TAB Punchlist

**CHICK-FIL-A
LINCOLN HIGHWAY FSR
1440 E. LINCOLN HIGHWAY
LANGHORNE, PA 19047**

FSR#05629

#29 [EXHA 999] [NEW] (MISC) Grease cleanout

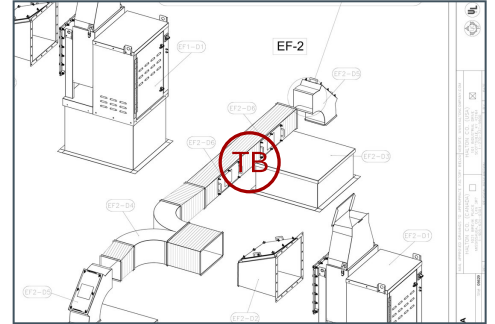
EF-2 needs another Greas cleanout installed on the Runout for HD-2. Specd is two cleanout in the run only one is cut-in and installed.

#28 [HOOD 508] [NEW] Sidejet arm angle bracket.

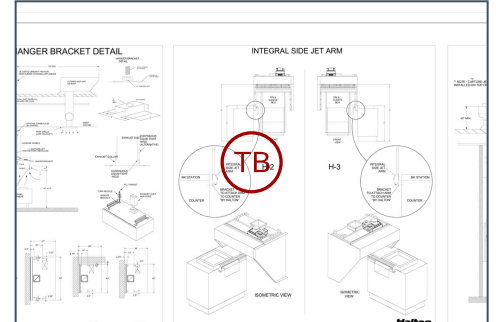
(HD-2)The Halton supplied angle bracket that connects the integral sidejet arm to the counter is missing or not installed correctly. Secure bracket to arm and bracket to counter underneath removeable fry dump via stainless steel rivets.

#24 [UNIT 517] [NEW] Condensate piping construction.

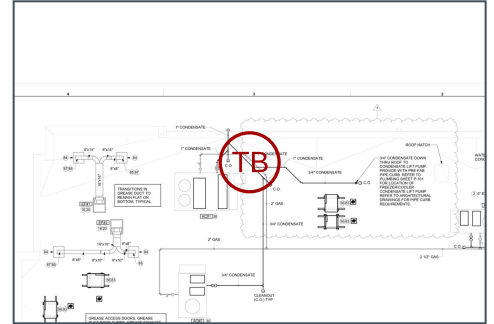
Equipment condensate piping Roof routing does not match prints.

#23 [UNIT 523] [NEW] Trane powered exhaust.

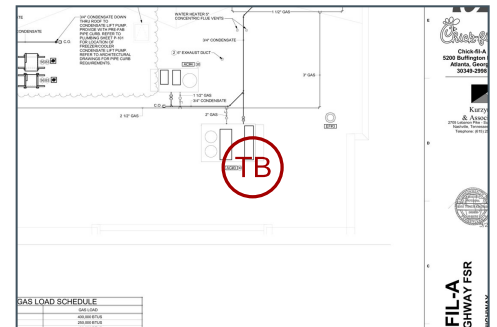
AC-3 Powered Exhaust fan wheel does not spin freely and rubs.

Item Reopened, Powered exhaust fan is rubbing again\

MC has adjusted the fan wheel and now spins freely.

#18 [REFG 999] [NEW] (MISC) WIF Thermometer

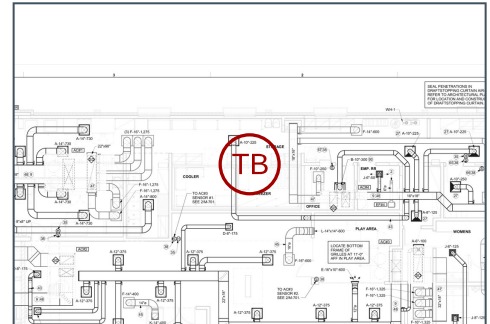
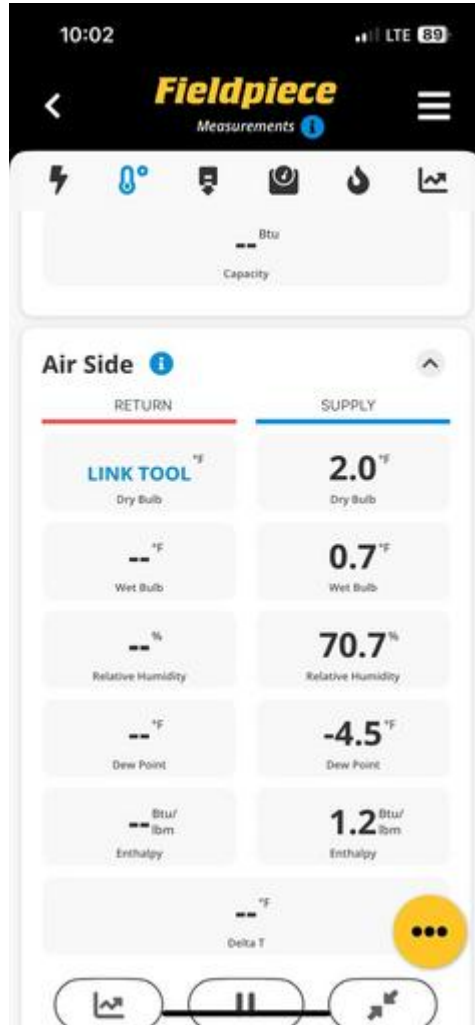
WIF Thermometer is not reading true to the Freezer Temp, Inside was 2F and thermometer is reading -15F
